# **8x930Hx (8x930HD/HE & 8x930HF/HG) SPECIFICATION UPDATE**

Release Date: February, 1999

Order Number: 272962-013

**Figure 1. RST Source From  $V_{CC}$  and  $V_{BUS}$**

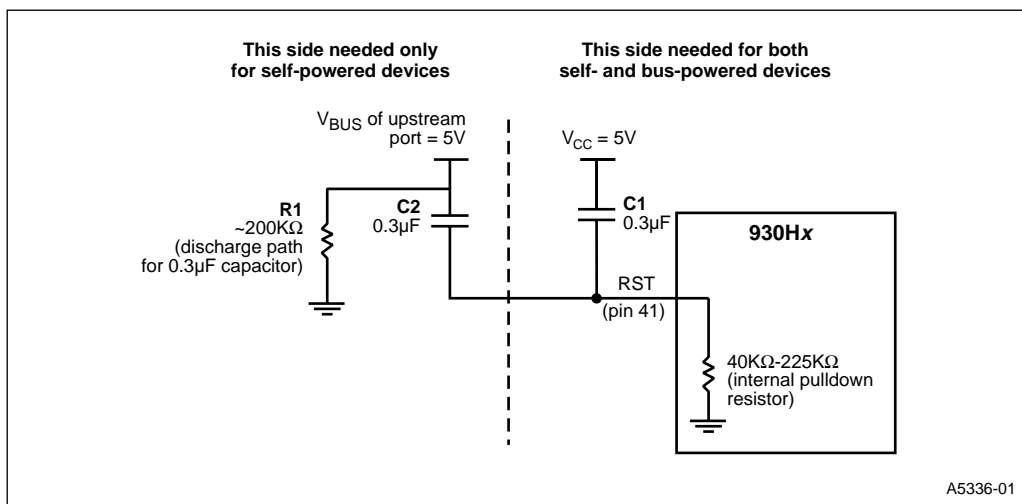
**PROBLEM:** When a self-powered, suspended hub is reattached to the host, it could be accidentally recognized as a low-speed device. This is caused by the 8x930Hx A-1 driving K signaling upstream and the host incorrectly sampling the speed of the device immediately after connect instead of after USB reset.

**WORKAROUND:** To fix this problem, you must modify the reset circuitry on current 8x930Hx designs. **Figure 1** depicts two circuits, one for a bus-powered hub and another for a self-powered hub. For bus powered devices, the circuit is the same one that is given in Figure 14-1 on page 14-1 of the *8X930Ax, 8X930Hx Universal Serial Bus Microcontroller User's Manual*, except the capacitor value has been changed from 1.0  $\mu$ F to 0.3  $\mu$ F.

For self-powered devices there are two requirements:

- The reset circuit design needs to be activated when the board is first powered-on.
- If the board is already powered-on, then a connection to the host should initiate reset. By connecting another capacitor to  $V_{BUS}$  (C2, as shown in **Figure 1**), a reset pulse is sent to the chip by either a power-up or by a USB connect.

- C1 — Used in conjunction with the internal pulldown resistor to generate a 20 ms pulse of reset. For bus-powered devices,  $V_{CC} = V_{BUS}$ . This creates a 20 ms pulse upon connection to the host. For self-powered devices, a 20-ms pulse will occur regardless of the state of  $V_{BUS}$  if the capacitor ratios remain 1:1. The circuit operation and timing relationships rely on  $C1 = C2$ .
- C2 — Used only for self-powered devices. The capacitor delivers a 20-ms pulse to the RST pin when the  $V_{BUS}$  signal is detected upon device connection.
- R1 — Provides a discharge path for C2. This resistor is mandatory. If R1 is not present, C2 will not discharge the reset pulse and therefore will not allow a proper chip reset during device connection.

Figure 5. External Code Fetch, Nonpage Mode

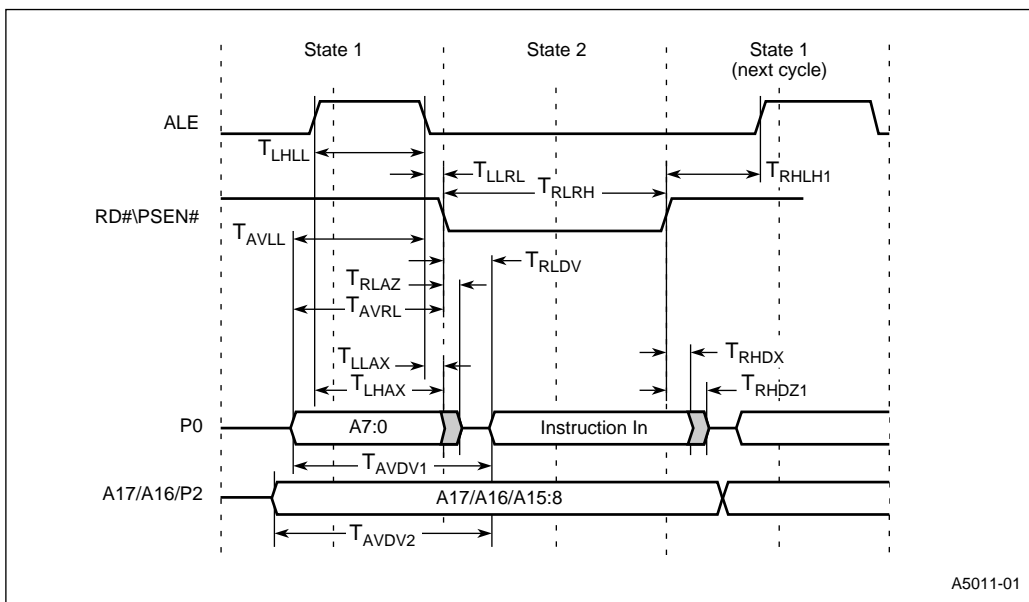
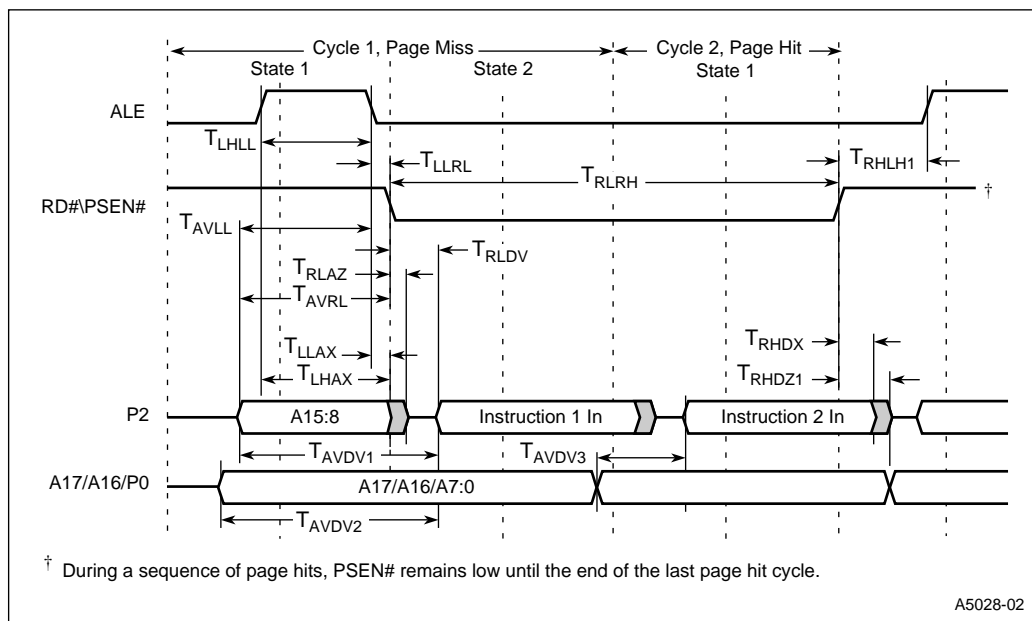
**PROBLEM:** The  $T_{RHDZ1}$  (Instruction Float After RD#/PSEN# High) specification on the 8x930Hx when operating at 12 MHz is 10 ns. However, a slow memory device such as an EPROM typically takes approximately 30 – 90 ns to float its output. (This specification, generically called  $TPHZ$ , may vary depending on the memory type and manufacturer.) Figures 5 and 6 illustrate the  $T_{RHDZ1}$  timing.

The difference between the  $T_{RHDZ1}$  and  $TPHZ$  specifications causes contention on the data bus (P0 in nonpage page, P2 in page mode). The 8X930Hx begins to drive the address for the next bus cycle while the memory device is still driving data from the previous bus cycle.
